Levy Nuclear Plant, Units 1 & 2

COL Application

Technical Specifications

Section A. PSTS and Bases Differences from the DCD GTS and Bases (LNP COL 16.1-1)

FIGURE 4.1-1 Low Population Zone and Site Boundary Map

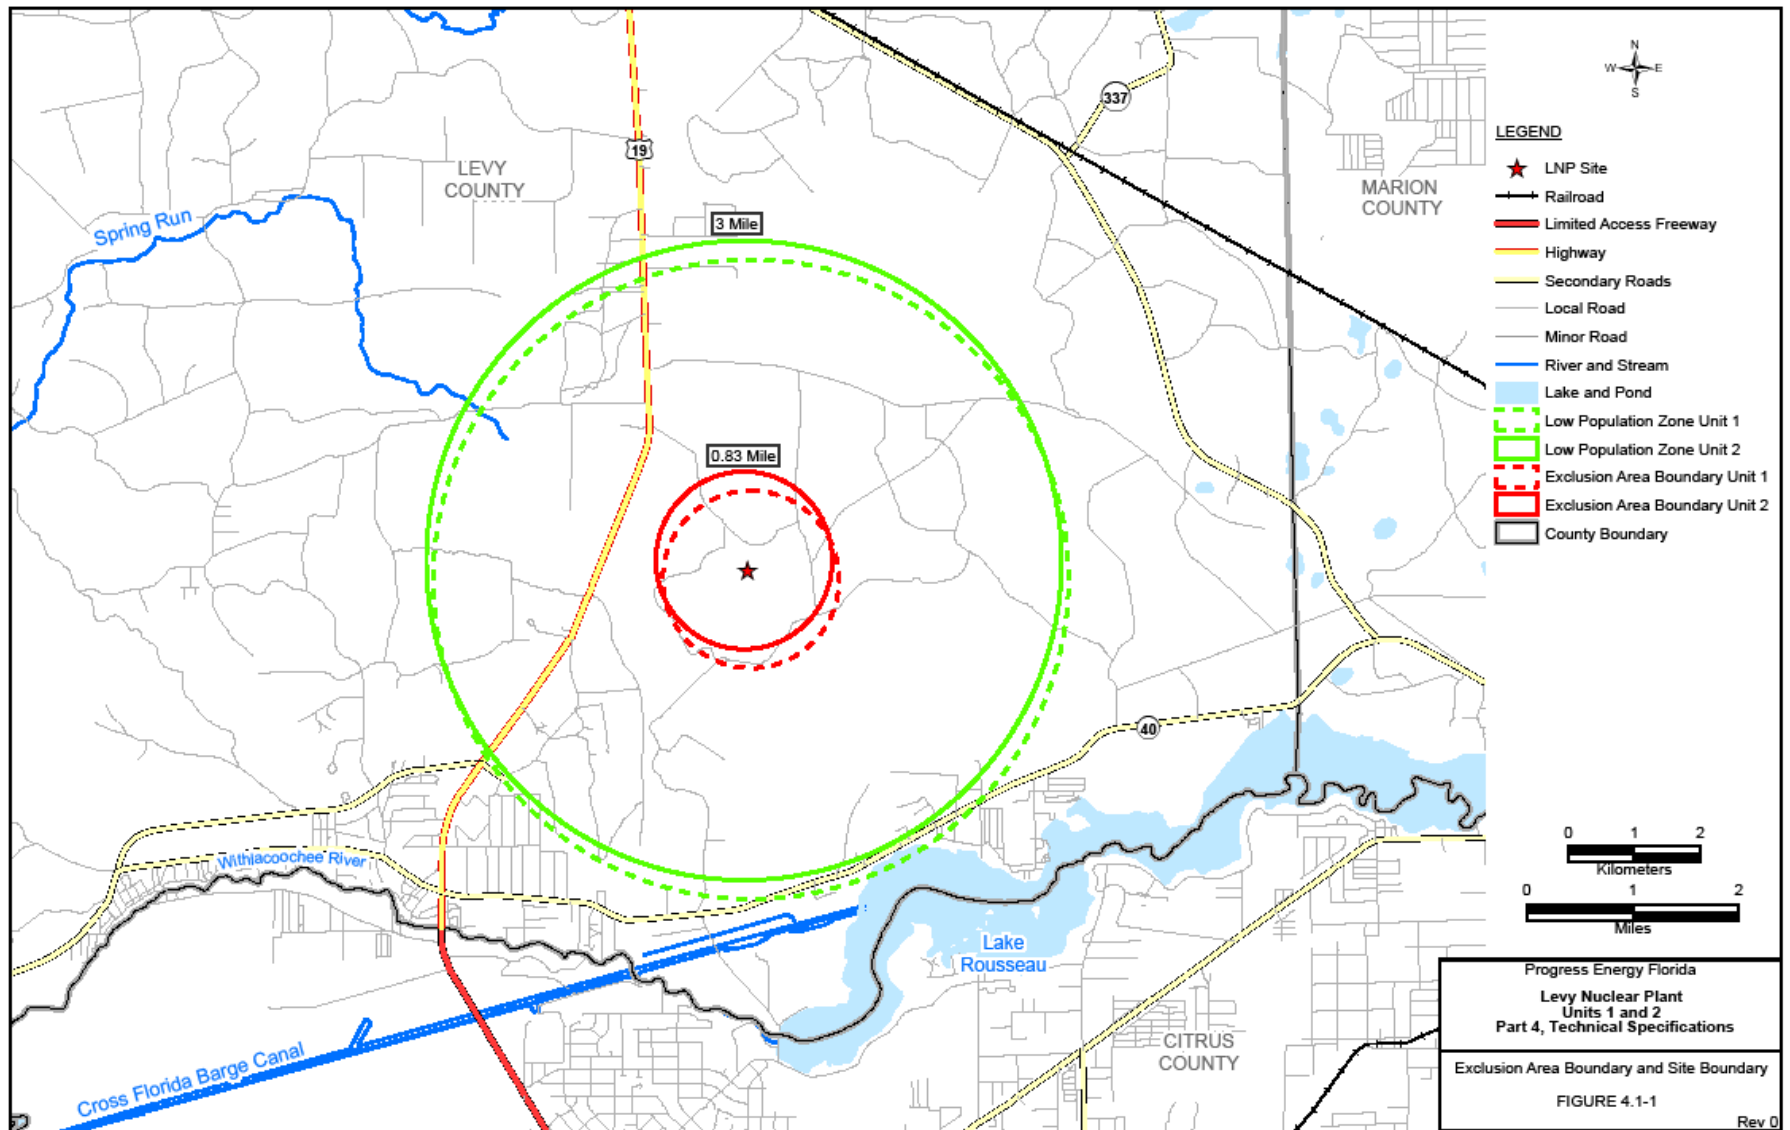
Replace the bracketed information in the GTS with the following:

The Site Boundary is shown in Figure 4.1-1.

Replace the bracketed information in the GTS with the following:

The LPZ is defined by the 3 mile radius from the site center point as shown in Figure 4.1-1.

FIGURE 4.1-2 Exclusion Area Boundary

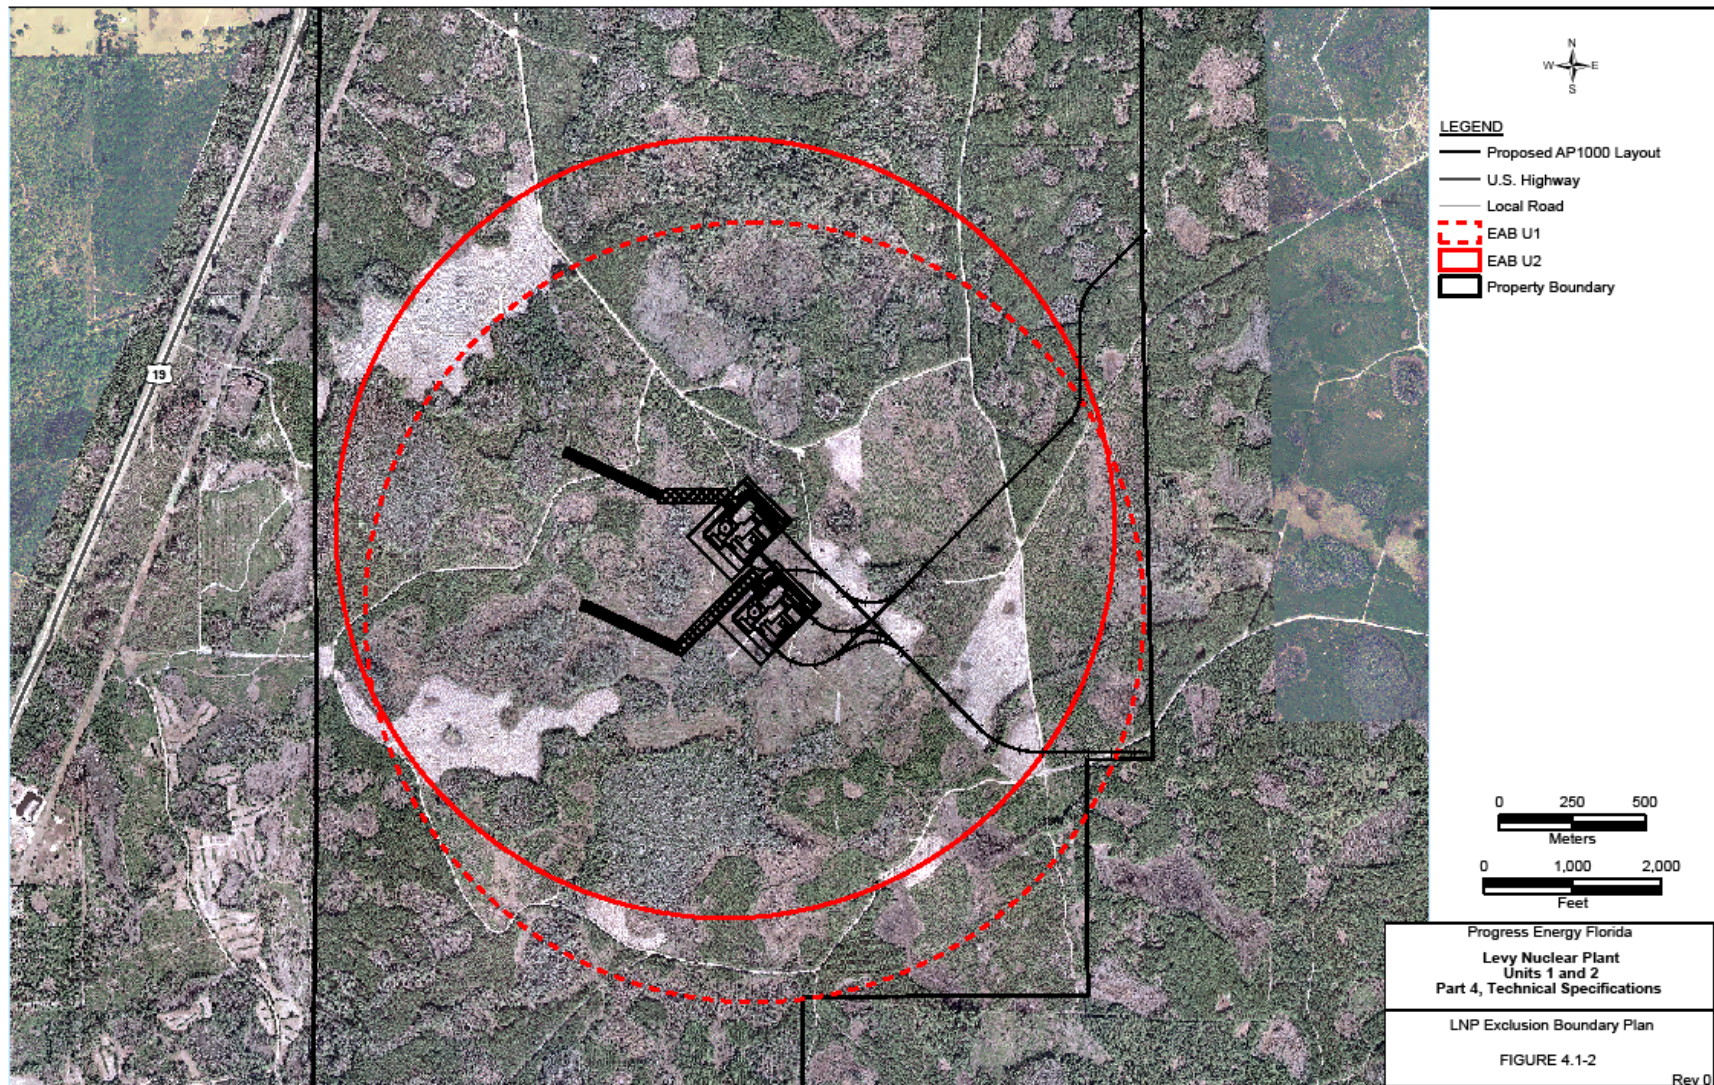
The Exclusion Area Boundary is shown in Figure 4.1-2.
